## Product Correction

Product Name	List Number	UDI
ARCHITECT c4000 Cuvette Segment	02P75-01	Not applicable
ARCHITECT c8000 Cuvette Segment	01G46-01	Not applicable
ARCHITECT c16000 Cuvette Segment	09D32-05	Not applicable

The following pictures show examples of cuvette segments where the base is detached from the vertical support post.

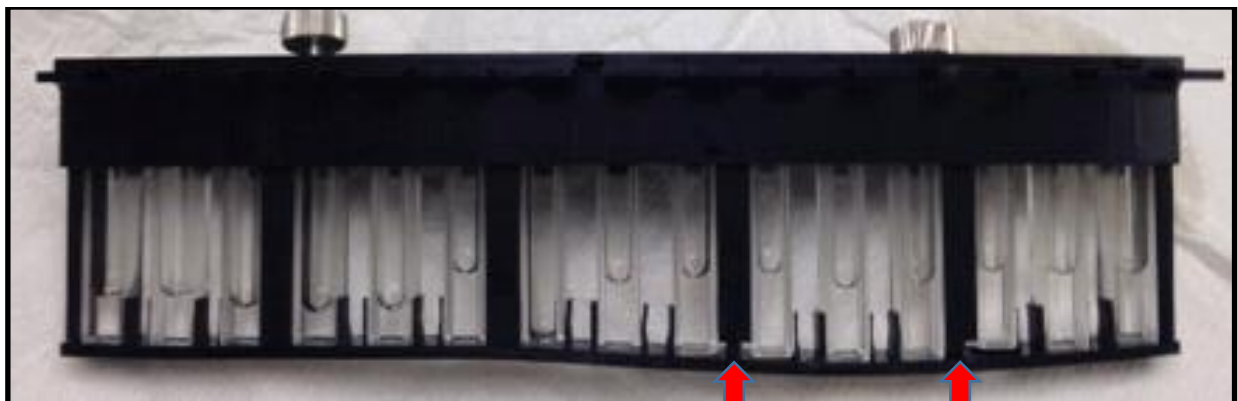
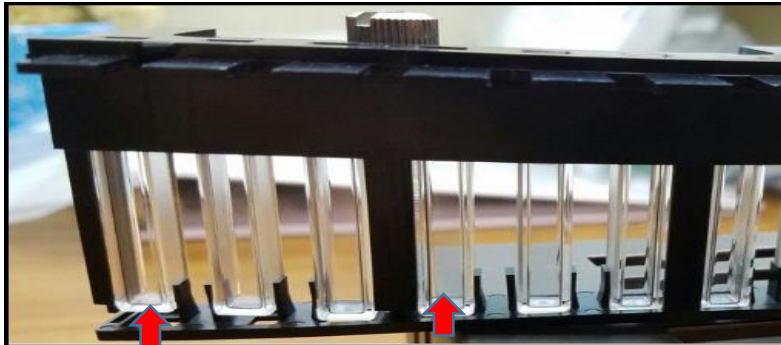
*The red arrows indicate where the base has become detached from the vertical support posts*

To remove the cuvette segments from the ARCHITECT for inspection, follow the procedure in ARCHITECT System Operations Manual Section 9 Service and maintenance, Component replacement, Replace a cuvette segment (c4000, c8000, and c16000). Wear gloves, as residual oil from an ungloved hand may cause imprecise optical reads. Once removed from the ARCHITECT, inspect each cuvette segment for damage by gently pulling downwards on the segment base at several points along the segment. If damage is discovered, replace the cuvette segment.
